## REVISED RESPONSE TO REQUEST FOR ADDITIONAL INFORMATION

### APR1400 Design Certification

Docket No. 52-046

RAI No.: 50-7911  
SRP Section: 07.02 – Reactor Trip System  
Application Section: 07.02  
Date of RAI Issue: 06/23/2015

Figure 7.2-28 Functional Logic Diagram for Reactor Trip Signal Generation

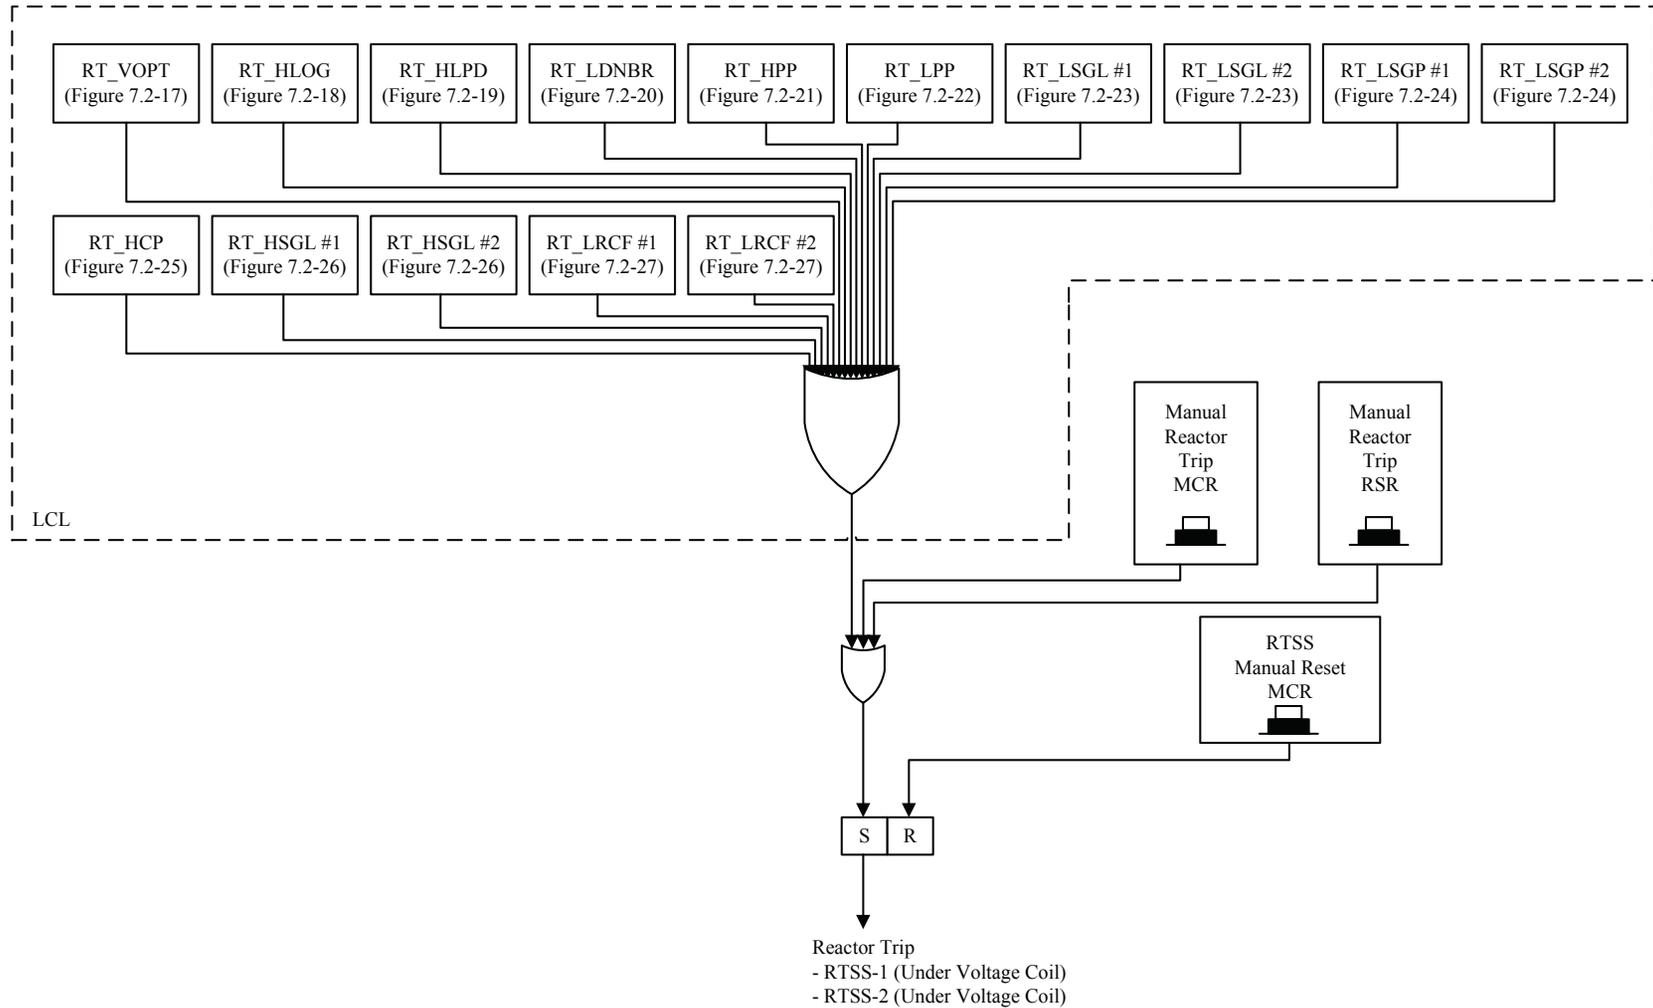
where the figures display only one division/channel (i.e., FSAR, Tier 2, Figure 7.2-10, “PPS Channel A Trip Path Diagram”) and where the schematics or diagrams of the figure display differences between the divisions/channels (i.e., FSAR, Tier 2, Figure 7.2-32, “Functional Logic Diagram for CWP”), insert a caption on the figures explaining whether the schematic or diagram shown is identical for all divisions/channels or insert a caption that describes what the differences are between the divisions/channels.

The description of identification is inserted into Figure 7.2-28 of DCD Tier 2 as shown in the attached mark-up for the case where some portion of the diagram shown in the figure is specific to certain channels or divisions. In this case, the manual reactor trip in RSR is applicable only for PPS divisions A and B. The remaining portion of the diagram in this figure is identical for all PPS divisions.

Note:

The manual reactor trip switches in the RSR are provided only for divisions A and B.
